ADA Curb Ramp New Construction Inspection Form (Parallel)

Shadybrook

24952.54

Yorkshire

PARALLEL RAMP (PL)

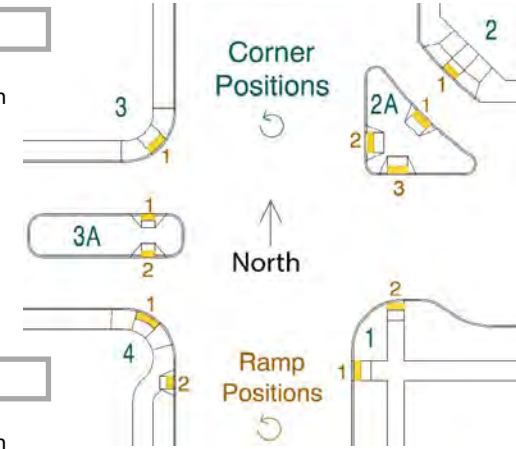
2.9 $\leq 2.0\%$ ☐ $> 2.0\%$ ☒

$\leq 2.0\%$ ☐ $> 2.0\%$ ☒

N Y ☐ N ☒

☐ 14.08 $\leq 8.3\%$ ☐ $> 8.3\%$ ☒

6 $\leq |5.0\%|$ ☐ $> |5.0\%|$ ☒

N Y ☐ N ☒

2.8 $\leq 2.0\%$ ☐ $> 2.0\%$ ☒

3.1 $\leq 2.0\%$ ☐ $> 2.0\%$ ☒

3.8 $\geq 4.0'$ ☐ $< 4.0'$ ☒

2.9 $\leq 2.0\%$ ☐ $> 2.0\%$ ☒

No Td.
